APPLICATION NO.	FILING DATE	FIRST NAMED INVENTOR	ATTORNEY DOCKET NO.	CONFIRMATION NO.
10/609,083	06/27/2003	James R. O'Brien	170933-00003	7446

Office Action Summary

DETAILED ACTION

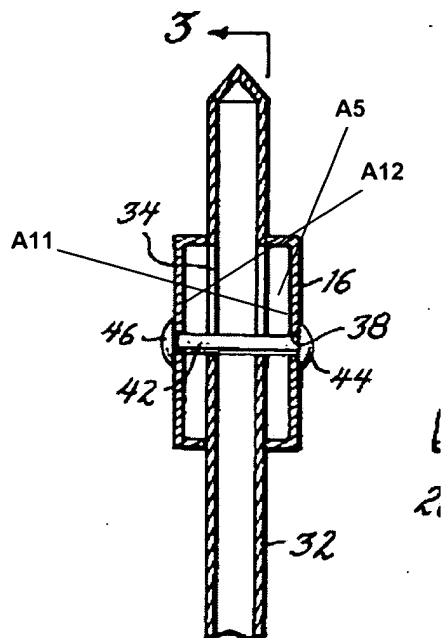
Regarding claim 1, Cusack discloses, in Figures 1 and 6, a rackable gate comprising a gate panel **10**, a spaced-apart rails **16,18**, spaced-apart first pickets **32**, a second picket **32** (of all the pickets shown one picket can be grouped as a second picket), and a pair of opposing gate posts **12,14**. The panel **10** has the spaced-apart rails **16,18** connected to the first pickets **32**. The second picket **32** is fastened to the spaced-apart rails **16,18** on a side **A5** opposing a fastening **42** of the first pickets **32** to the spaced-apart rails **16,18**. The gate posts **12,14** each define openings **48** in a side

Regarding claim 9, Cusack discloses, in Figures 1, 2 and 6, a rackable gate comprising a pair of elongate rails **16,18**, first pickets **32**, a second picket **32**, and opposing gate posts **12,14**. The rails **16,18** comprise a first rail **16** and a second rail **18** each disposed in parallel spaced-apart relation and at an angle relative to horizontal. The rails **16,18** each define an opposing first side edge **A11** and a opposing second side edge **A12**. The first pickets **32** are attached to the first rail **16** and the second rail **18** by fasteners **42** between the first pickets **32** and the opposing first side edge **A11** of the rails **16,18**. The second picket **32** is attached to the first rail **16** and the second rail **18** by fasteners **42** between the second picket **32** and the opposing second side edge **A12** of the spaced-apart rails **16,18**. The gate posts **12,14** define openings **48** in which the distal ends **A10** of the rails **16,18** are pivotally secured.

Fig. 6.

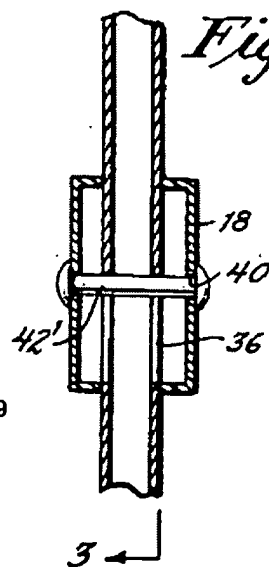
wall **A9**. The openings **48** are spaced-apart and conform to the spacing of the spaced-apart rails **16,18**. The openings **48** receive distal opposing distal ends **A10** of the spaced-apart rails **16,18** pivotally secure thereat.
